RE: **Juan Tabo Hills Estates**
Revised Grading Plan
Engineer's Stamp Date: 7/12/18
Hydrology File- M21D018; DRB# 1005278

Based on the submittal received on 7/20/18, the revised grading plan cannot be approved until the following are corrected:

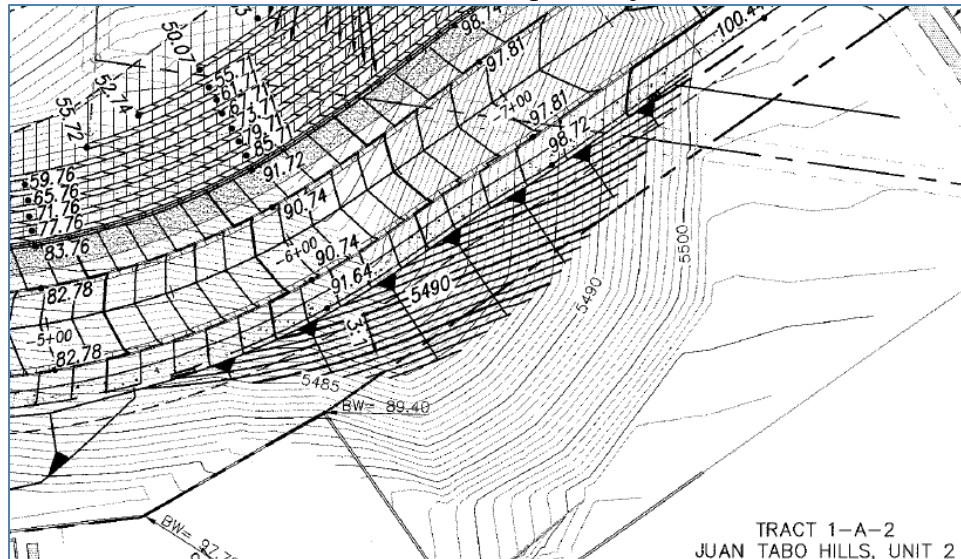
1. Fill in or provide an armored drainage conveyance for the low spot south of the Rocky Top entrance. This area cannot be allowed to pond adjacent to the road embankment:

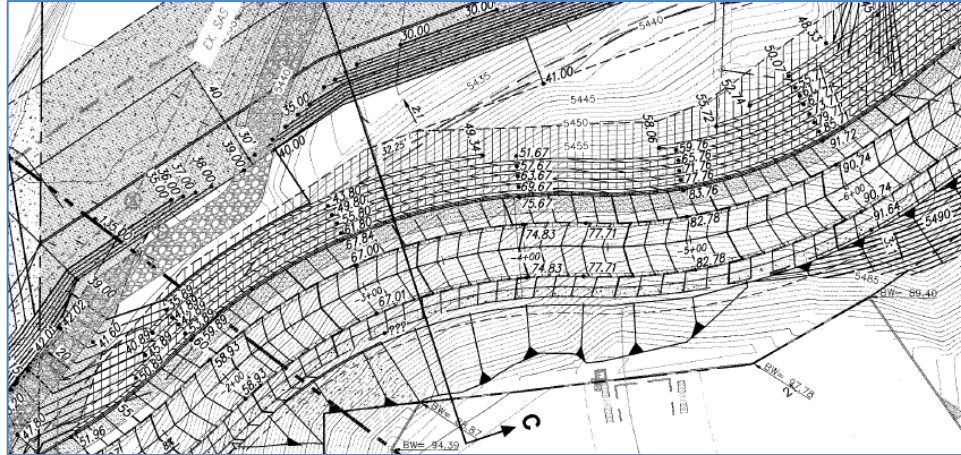
2. Provide the sections shown on the grading plan.
3. Provide an armored drainage conveyance for the interspaces between the terraced retaining walls and down into the storm water pond; ensure the AMAFCA access road is protected from this runoff:

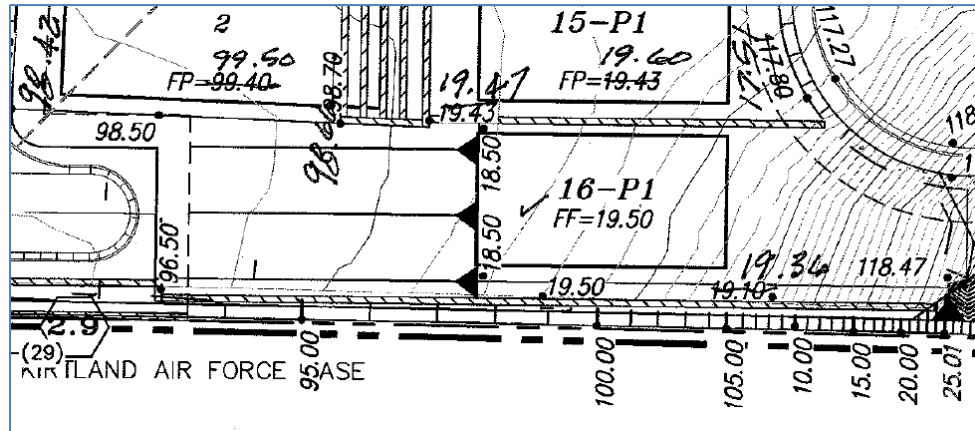
4. Please verify that the AMAFCA maintenance ramp, gate, and retaining walls are consistent with the current bank protection plans:

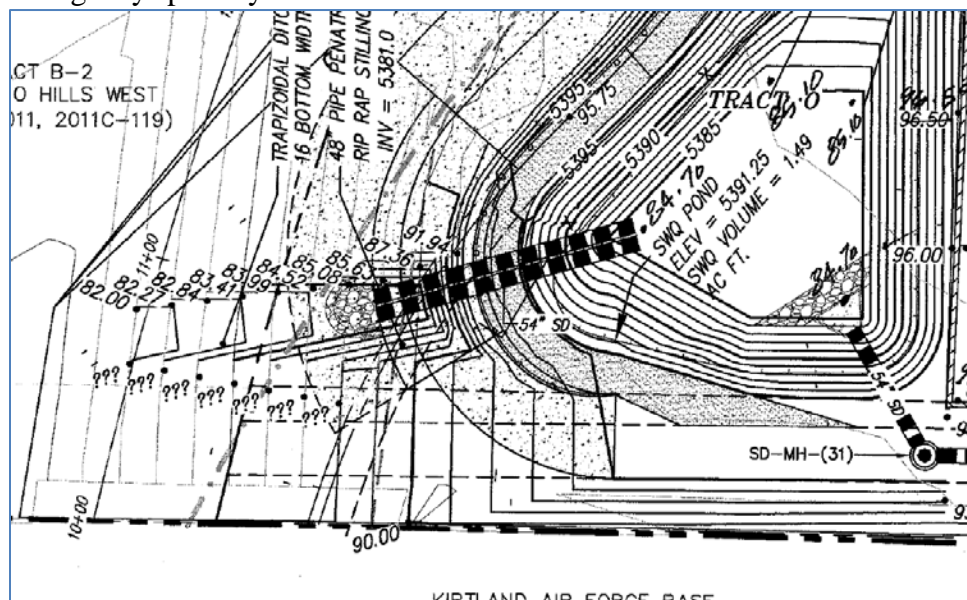
7. Many of the Lots have been re-numbered. Is this intentional? This will need to be updated on the amended preliminary plat as well. Look at: Block 19, Block 14, Block 13,
8. Lot 8(?) of Block 12 is not labeled. Lot 6(?) of Block 4 is not labeled. Lot 6(?) and Lot 7(?) of Block 2 are not labeled.
9. The pads for: Lot 1- Block 14, Lot 1- Block 15, Lot 16- Block 9, encroach into the ROW; please correct.
10. Explain the switch to the dual pipe penetration at the SW pond. Is this reflected in the bank protection plans? Where are its build notes? It is still labeled as a single 48" pipe. The grading for the AMAFCA access ramp should be shown here as well as the grades for the emergency spillway:

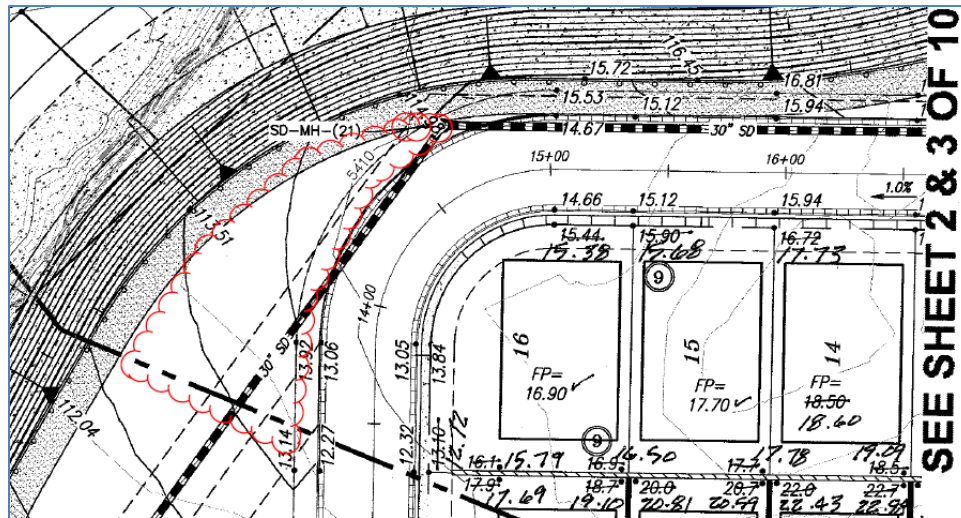
11. Will this pond still function as a first flush facility? If not, than payment of the Fee-in-Lieu will be required at a rate or \$6/cf for the SWQ volume.
12. Provide rip-rap armoring at the outside bend of Sandia Sunset. If water surcharges out of the NMDOT inlet upstream near MH-47, flows will travel overland down Sandia Sunset and will likely jump the curb at this bend:
